Parkside Cemetery Arches

- The direct residents to the Parkside Cemetery in Dundas are asking that more public consultation take place before two 17x 25 ft metal arches are installed at the entrances on Parkside Avenue.

A photo of the city web site shows the only documentation available to residents before September 9, 2021

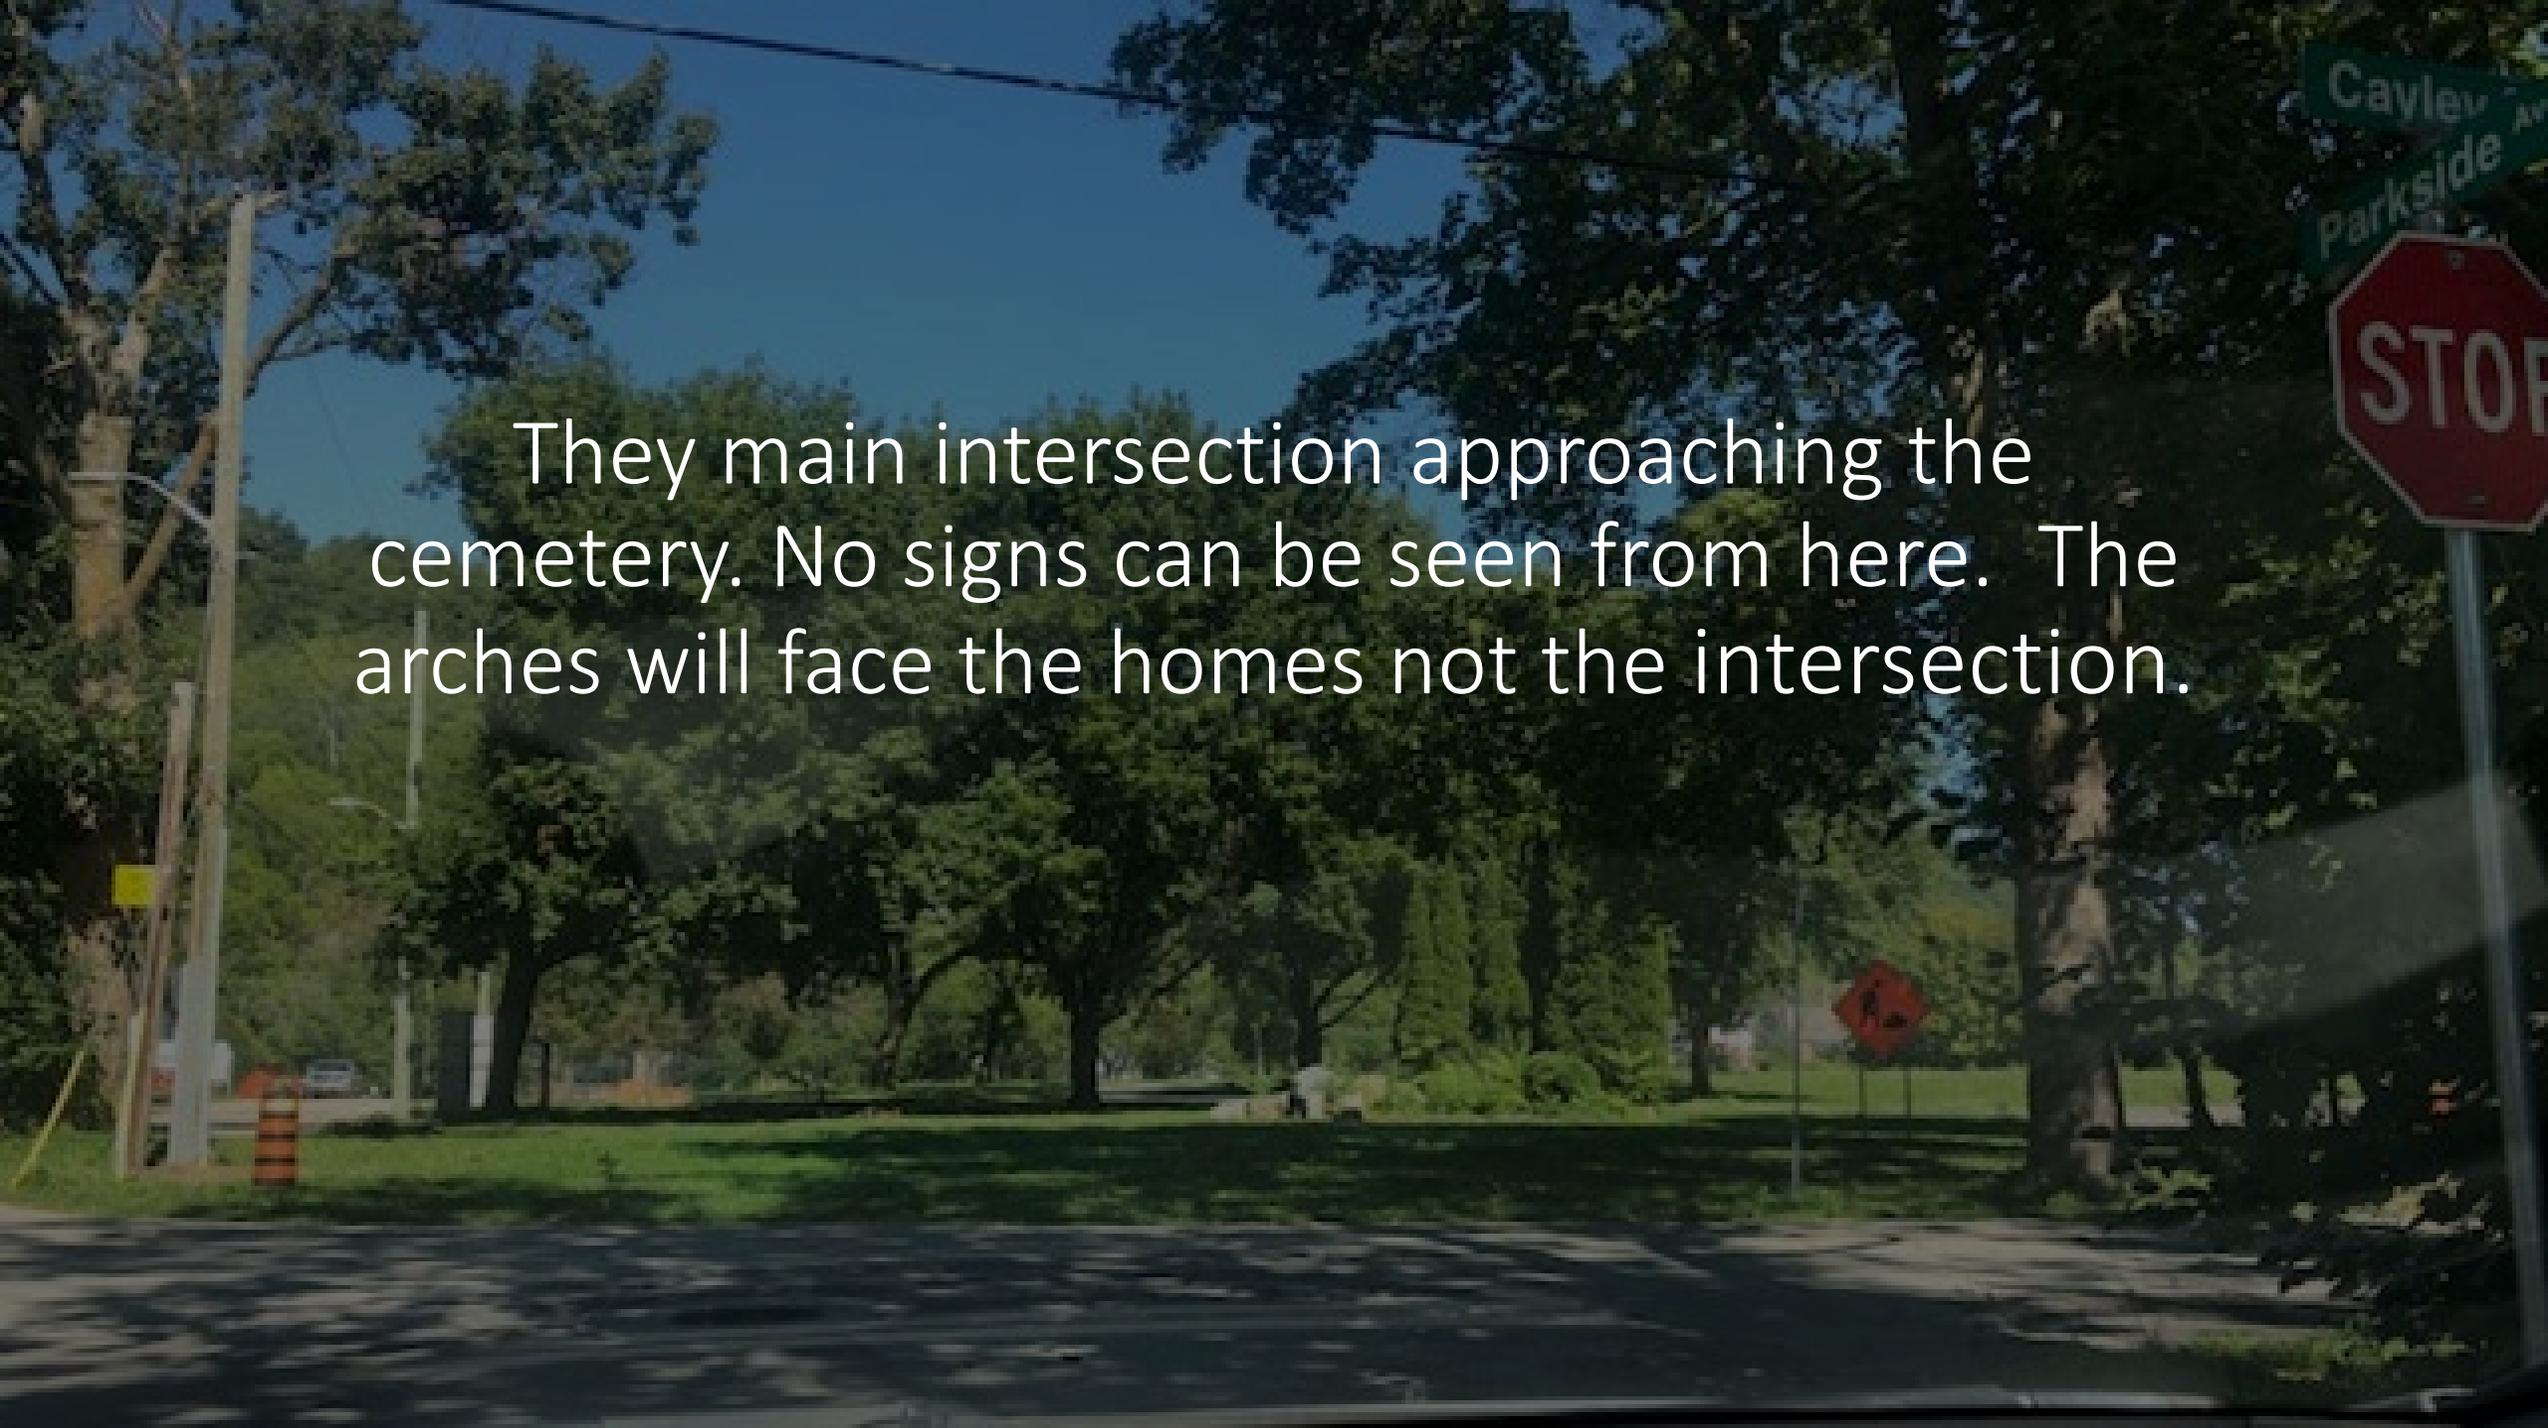
- The concept plan posted on the city website as "revised based on comments from public consultation."
- There is one entrance arch located at the back of the site.
- There are no arches on Parkside Avenue.
